June 2017

Change of recommended tightening angle

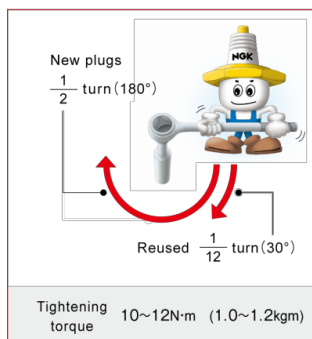
Please note the recommended tightening angle for some NGK Spark Plugs with 10mm thread diameter has changed.

Refer to the following chart to determine which NGK Spark Plugs require the new **90 degree tightening angle**: Please note the original tightening torque value of 10 – 12 Nm has not changed
